**MAINE TURNPIKE AUTHORITY**

**ADDENDUM NO. 2**

**CONTRACT 2023.10**

**MTA HEADQUARTERS BUILDING**  
**IMPROVEMENTS PROJECT**

SHEET NUMBER: AD-4

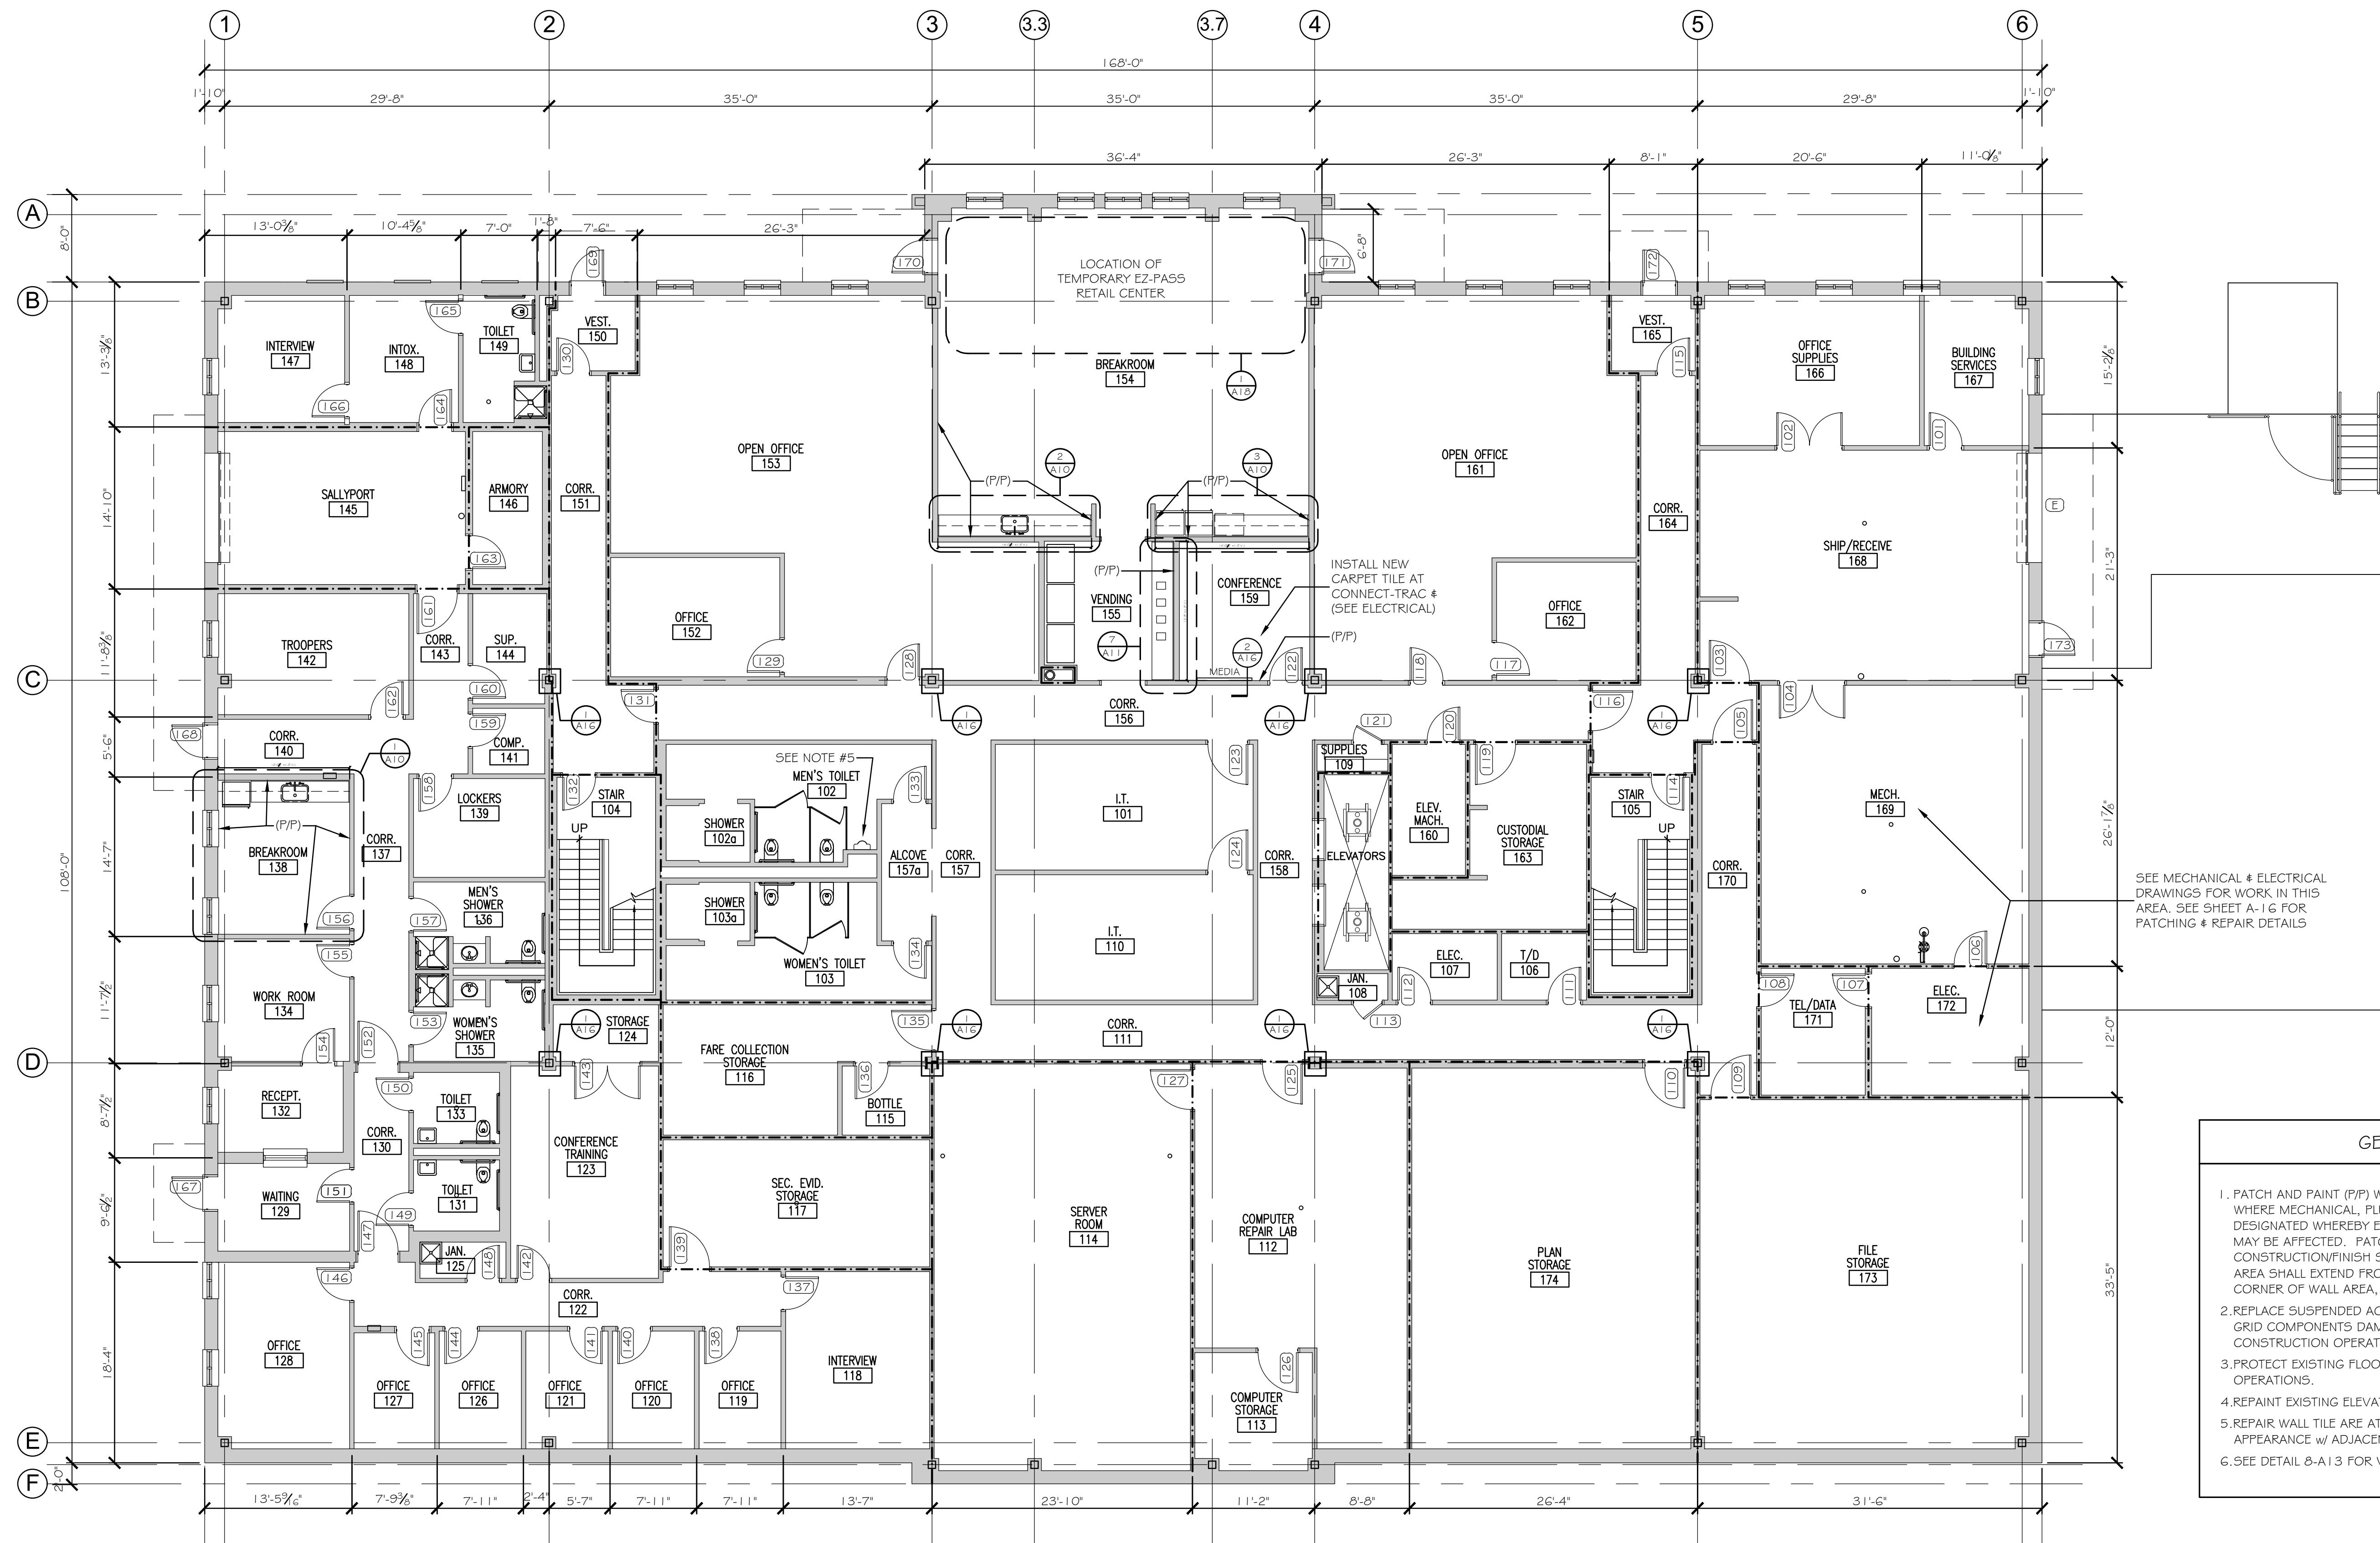
Question 13: In the Building Renovation Lump Sum, do we include the replacement of damaged patio pavers? Does this a deduct in Bid Item 608.082?

Answer: The Building Renovation Lump sum Pay Item 800.01 is not intended to include patio work. The two patio side areas denoted as “29” in detail A on plan sheet AD-4 and denoted as “Pay Item 608.082” in the “Front Entryway/Patio Plan” detail on plan sheet G-003 will be paid for in one of two ways. IF the MTA chooses to retain the two existing patio side areas, the contractor will be paid by Pay Item 608.10 “Brick Sidewalk (Remove and Rebuild)” to replace the broken pavers with salvaged pavers removed from the lower section as noted in note “16” in detail A on plan sheet AD-4. IF the MTA chooses to remove the pavers in the two existing side patio areas and replace with a reinforced concrete sidewalk, the contractor will be paid by Pay Item 608.082. See specification 608 for work that is considered incidental to both pay items. The intent is not to utilize both pay items and the item that is not utilized will be deducted from the contract through a change order.
